RE: Joseph M. Farley Nuclear Plant - Units 1 and 2
Degraded Electrical Power Grid Conditions

ENCLOSURE

FIGURE 1- OPERATION OF CV-2 DEGRADED GRID
UV RELAY WITH LOCA TRANSIENT
SIMULTANEOUSLY OCCURRING WITH DEGRADED
GRID CONDITION

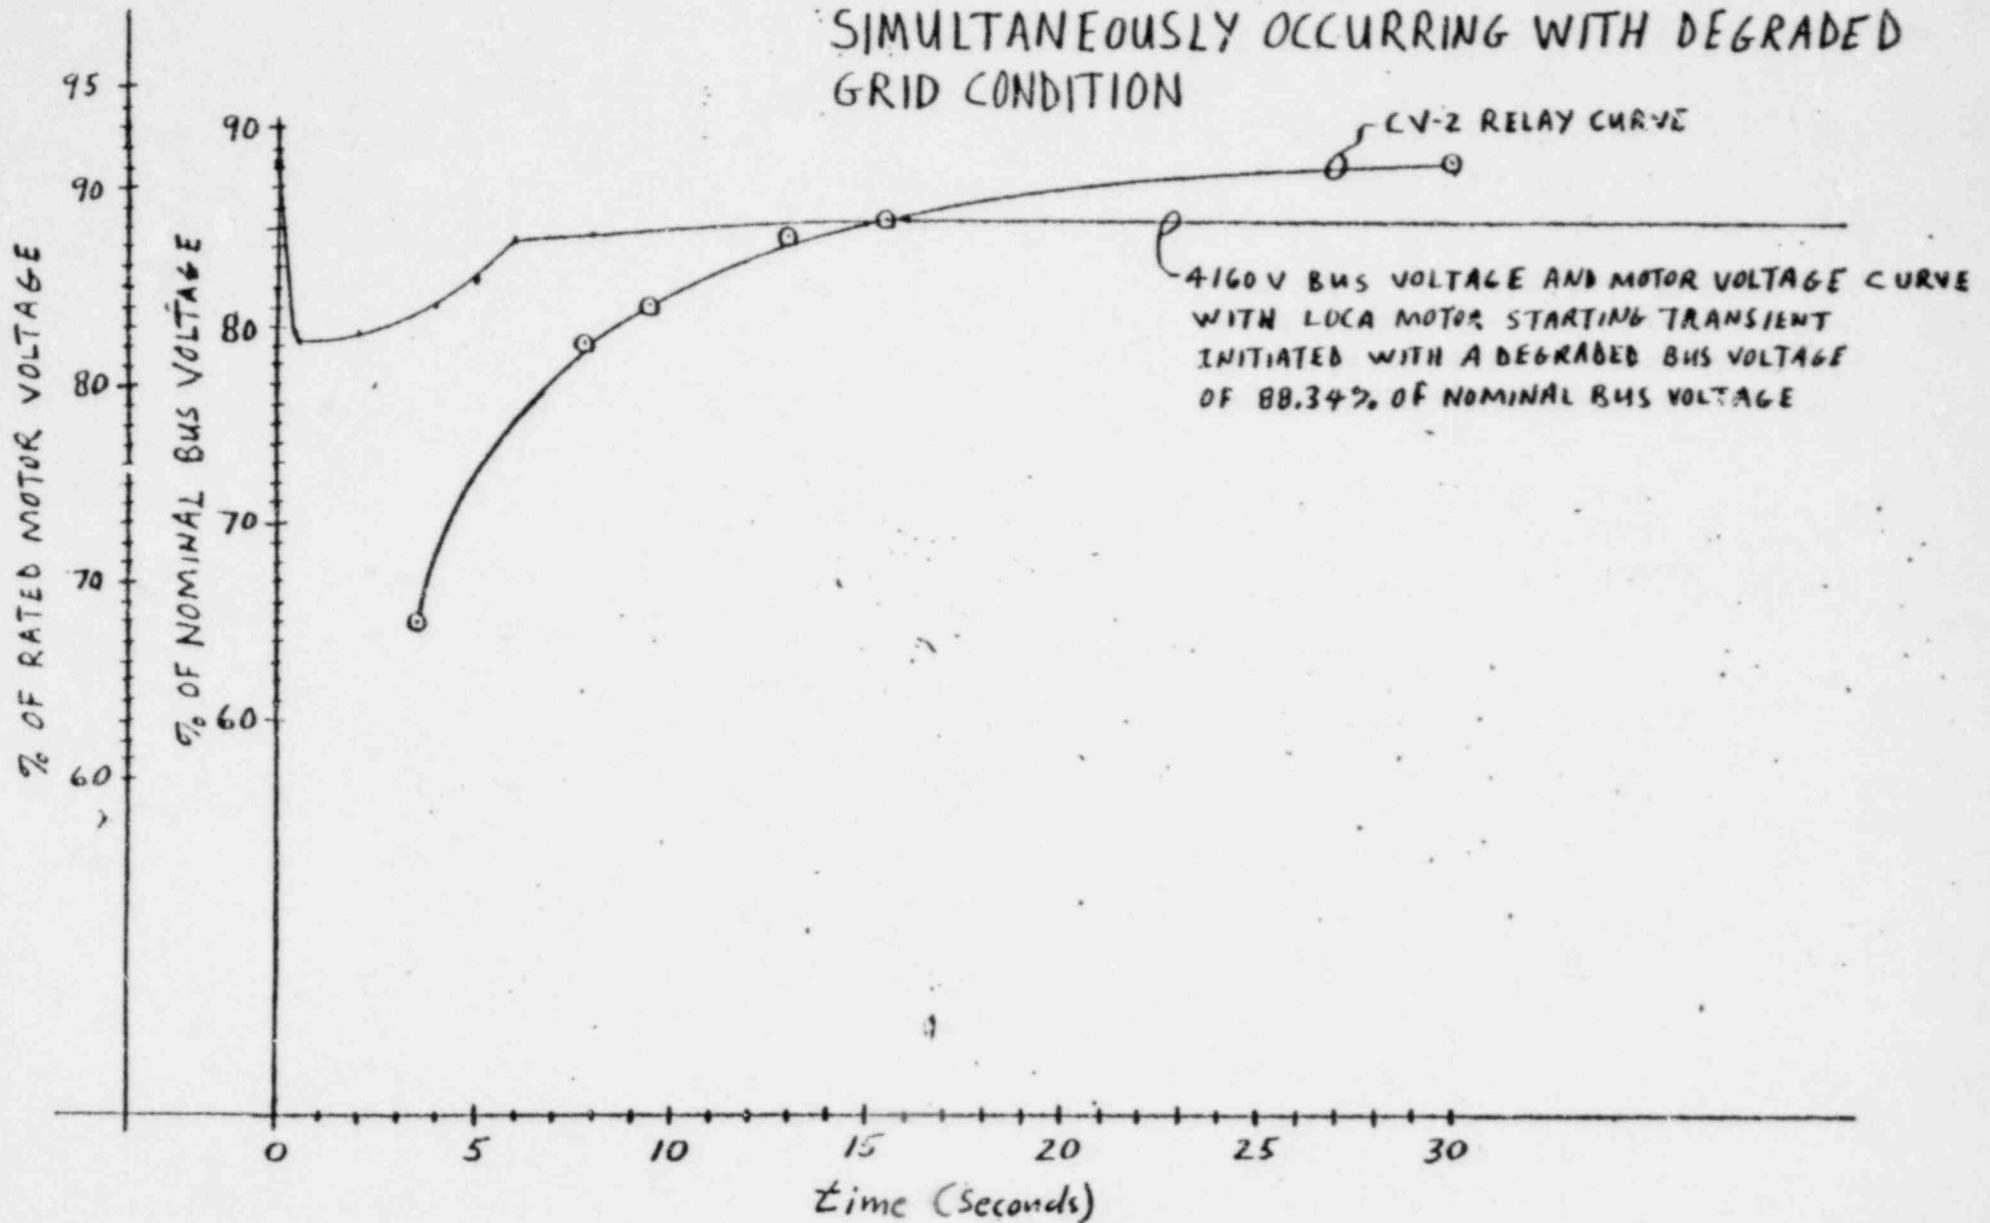
In regard to NRC Position 1, the NRC has requested APCo to demonstrate for a degraded voltage condition that the time delay chosen does not exceed the maximum time delay assumed in the accident analyses. The following response will demonstrate for a degraded voltage condition that the existing Degraded Grid Voltage Relay and Loss of Voltage Relay settings meet the response times assumed in the FSAR Accident Analyses for the Engineered Safety Features Systems. Two scenarios must be addressed to demonstrate the adequacy of the design. The first scenario would be to postulate an accident with a degraded grid voltage condition where the 4160V safeguards bus voltage is degraded but is still of a sufficient magnitude to allow the safeguards motors to start and accelerate, and the second scenario would be to postulate an accident with a degraded grid voltage condition where the 4160V safeguards bus voltage is degraded to a level where the safeguards motors cannot start and accelerate.

For the sequence of events tables presented above, the tolerances on the voltage trip point and the time delay for the CV-2 Loss of Voltage and Degraded Grid Voltage Relays were not included. The relay voltage trip band will be plus or minus 1% of the calibrated trip point, and the relay time delay trip tolerance will be plus or minus 5%. Due to the magnitude of the differences between the engineered safety features response times tabulated above and the maximum time delays assumed in the FSAR Accident Analyses, inclusion of the relay tolerances will not alter the conclusions stated above, i.e., the maximum time delays assumed in the FSAR Accident Analysis will not be exceeded.
